**UPPER UWCHLAN TOWNSHIP
PLANNING COMMISSION
AGENDA
January 13, 2022
7:00 p.m.**

Reference: Greenridge Road Conditional Use Plan (Toll)
Conditional Use Plan Review (3rd Review)
Upper Uwchlan Township, Chester County, PA

CONDITIONAL USE SUBDIVISION PLAN FOR GREENRIDGE ROAD

PLAN VIEW
SCALE: 1"=50'

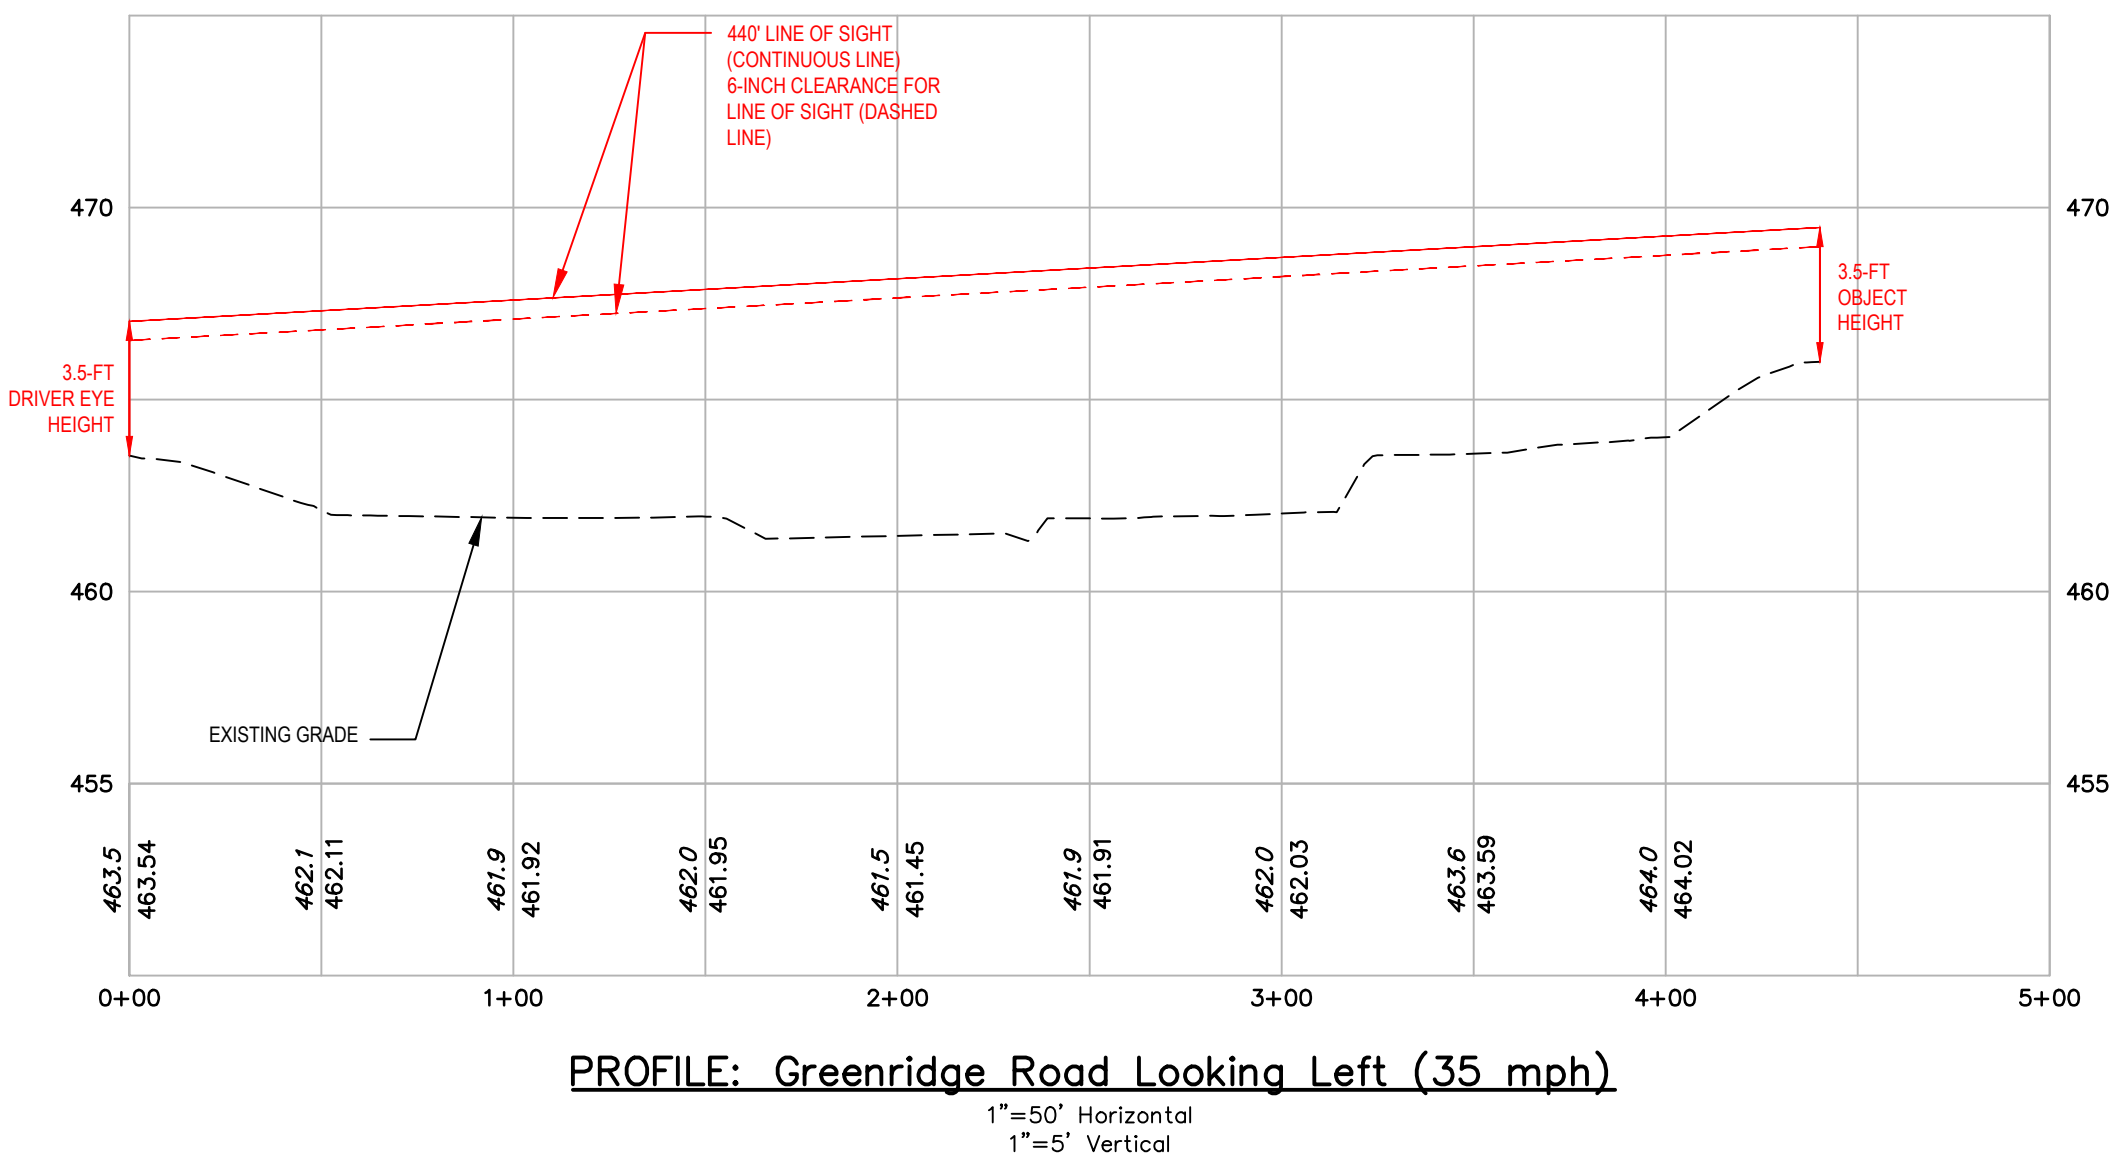
1. **(W)** Section 162-30.A – *Maximum grade for a local access road is 10%. The applicant is requesting a waiver to permit a maximum grade of 12%. If this waiver is to be considered as part of the conditional use process, a plan and profile of the roadway should be provided so an evaluation can be made. Otherwise, we would recommend this waiver request be defer until the land development submission.*

2. SALDO Sections 162-30.A – The applicant requests a waiver to allow an 11 percent grade along a section of Road A between Lots 4 and 64, which exceeds the required maximum grade along local streets of 10 percent. Based on the vertical profiles provided, it appears possible to revise the design to provide a maximum 10 percent grade (between STA 8+87.5 and STA 15+25) by increasing the 6.08% grade (between STA 17+50 and STA 24+65) to seven percent, which would no longer require the requested waiver. As such, at this time, we do not support the waiver to allow the 11 percent grade. We recommend any decision on this waiver request should be deferred to land development when more detailed engineering information is available.

As requested, the Applicant has provided a plan and profile indicating the proposed vertical alignment for the roadway. Based on our review of the submitted profile, it appears there may be an opportunity to reduce the slope of the section currently proposed to be constructed at 11% to 10% and increase the section of road currently proposed to be 6.08% to approximately 7% which would eliminate the need for this waiver. While we have no objection to the granting of this waiver to allow the roadway to be constructed as currently designed, we believe our above suggested configuration should be considered first.
